SEQUOYAH NUCLEAR PLANT (SQN) - FEEDWATER (FW) CHECK VALVE CLOSURE
FOLLOWING PIPE RUPTURE - RESPONSE TO INSPECTION REPORT 87-27, OBSERVATION
MEB-3

- References:
1. NRC letter to TVA dated August 24, 1987, "Sequoyah Design Calculation Review: Report Nos. 50-327/87-27 and 50-328/87-27"
 2. TVA letter to NRC dated May 16, 1979, "Sequoyah Nuclear Plant Units 1 and 2 - Potential Excessive Water Hammer Forces in the Main Feedwater System - NCR MEB 79-1 - Final Report"
 3. TVA letter to NRC dated October 10, 1979, "Sequoyah Nuclear Plant Units 1 and 2 - Potential Excessive Water Hammer Forces in the Main Feedwater System - NCR MEB 79-1 - Revised Final Report"
 4. NRC letter to TVA dated November 16, 1979, Inspection Report 50-327/79-63 and 50-328/79-31

The purpose of this submittal is to discuss the FW water hammer issue as it relates to SQN units 1 and 2. Initially addressed in the 1979-1980 timeframe and formally dispositioned, this item has again been raised and requires subsequent discussion. Most recently, NRC Inspection Report Nos. 50-327/87-27 and 50-328/87-27 (reference 1) concluded that the SQN water hammer issue (Observation No. MEB-3) "remains open pending (a) CEB's documented

FIGURE 1

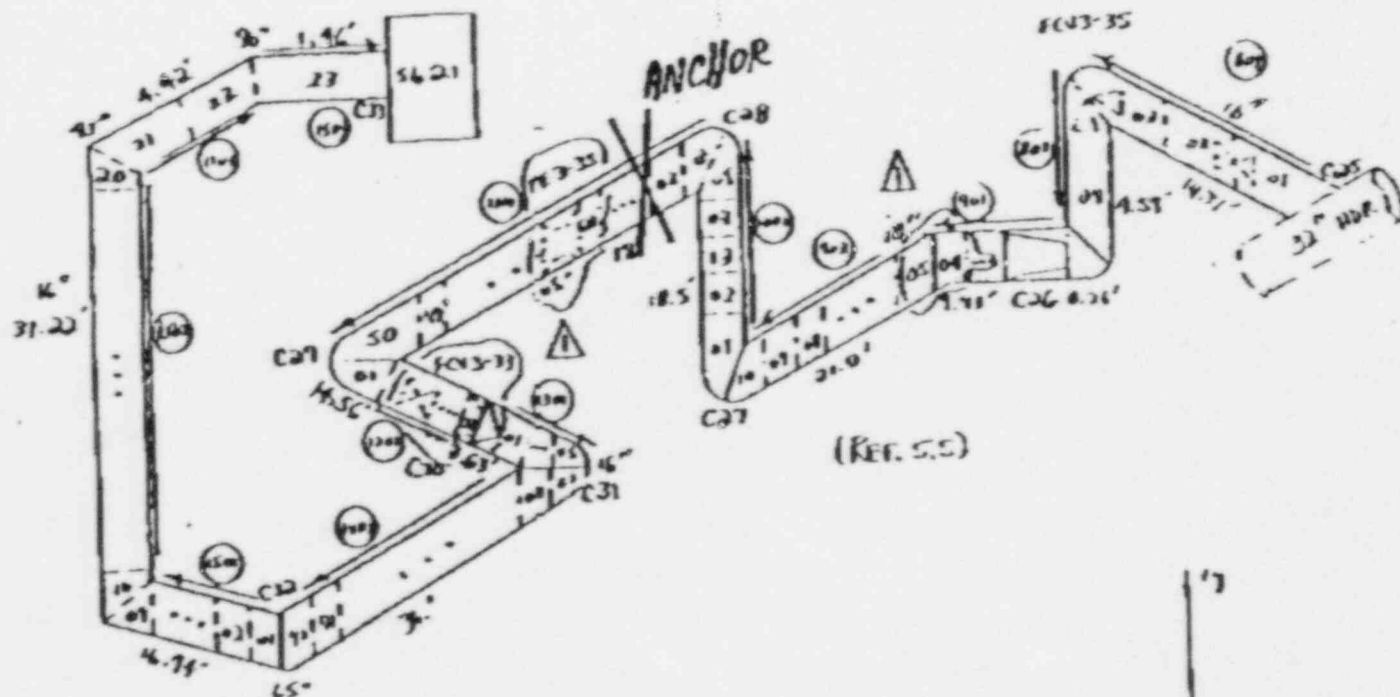
Each of the FW piping loops differs slightly (see Fig. 1) between the SG nozzle and the first anchor outside containment. Segment 1101 in Figure 2 contains this anchor for Loop 1 to SG 1 at Sequoyah Unit 2. The piping from the first anchor to the SG is approximated and modelled for input to the DINASAW program. Force-time histories developed for the check valve closure following postulated pipe rupture in the FW header are applied to critical pipe segments.

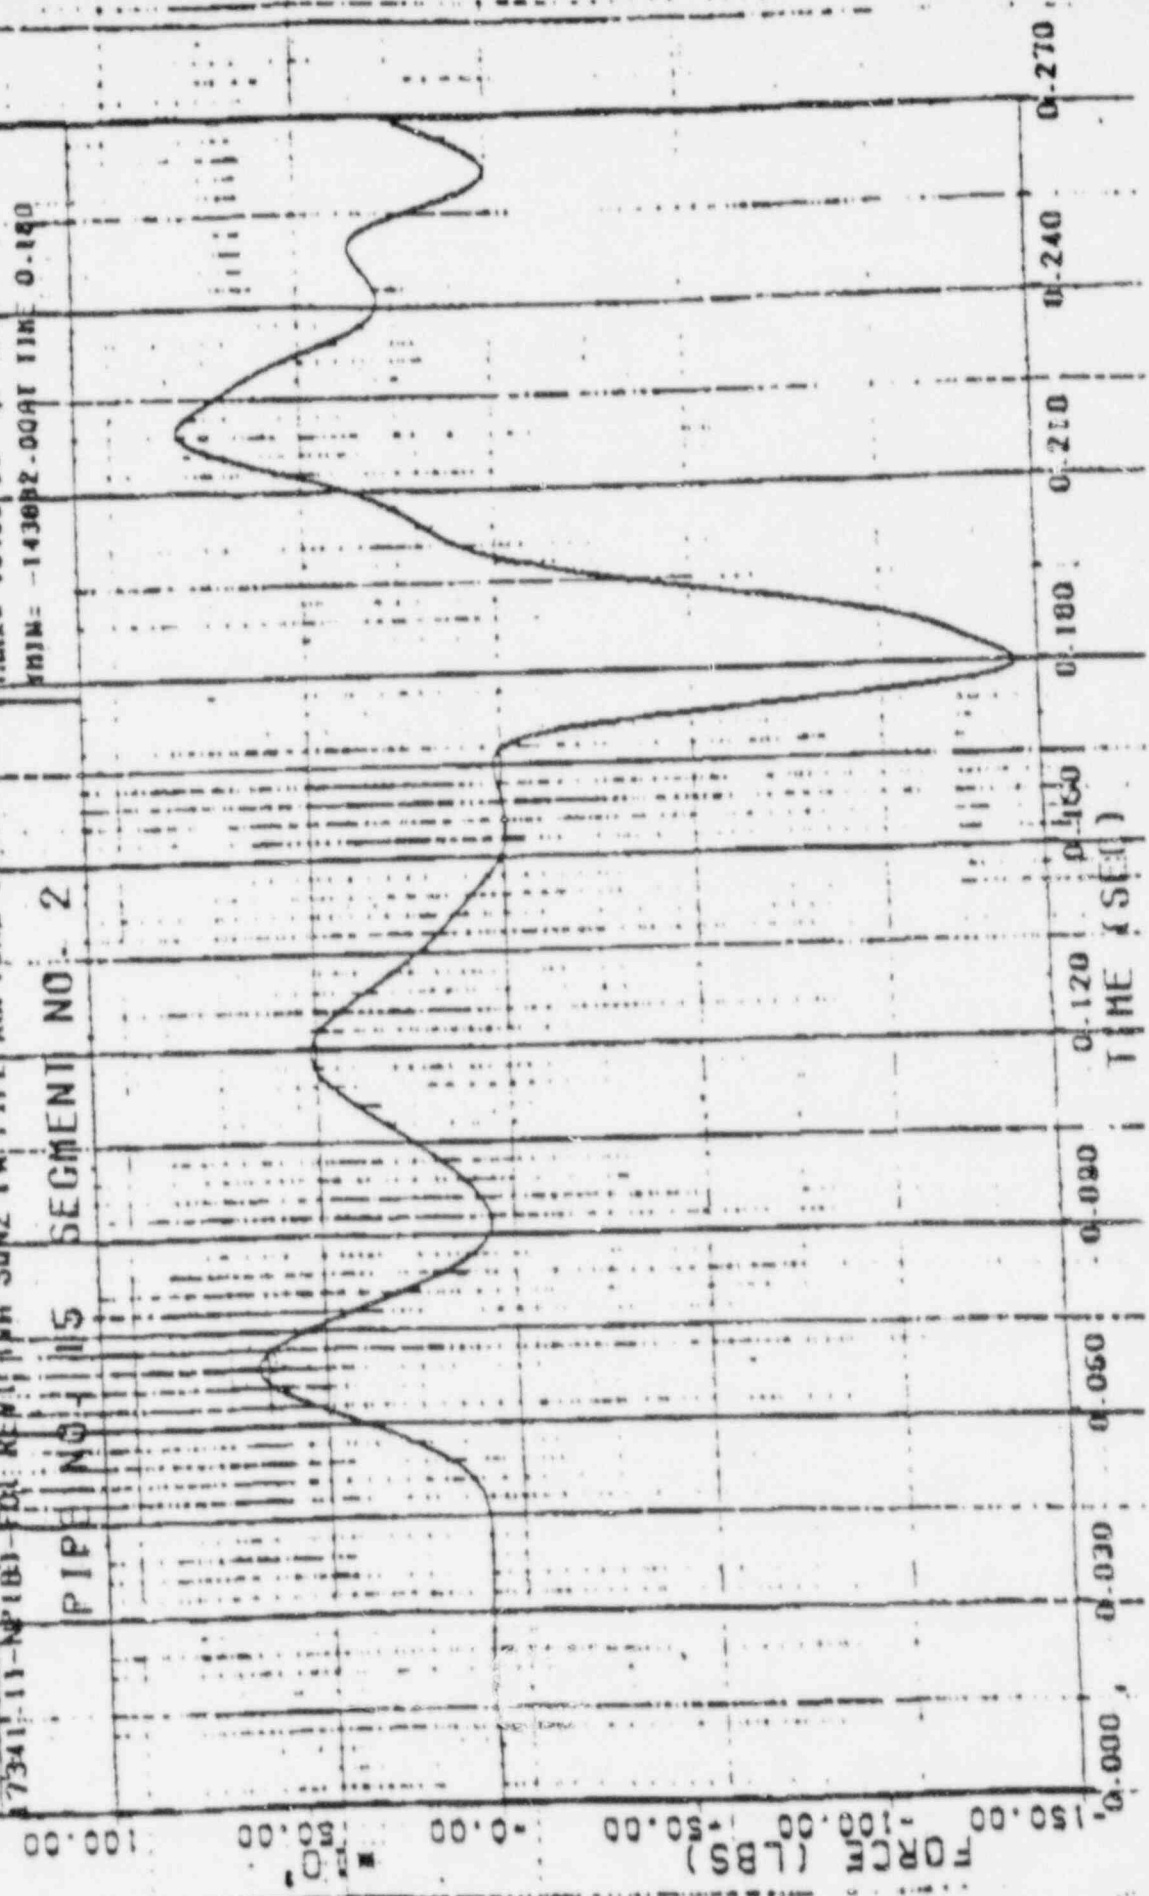
Figure 3 shows the force-time plot for segment 1502, which appears to be the most critical segment for this SG loop. Other pipe segment forces will be evaluated also.
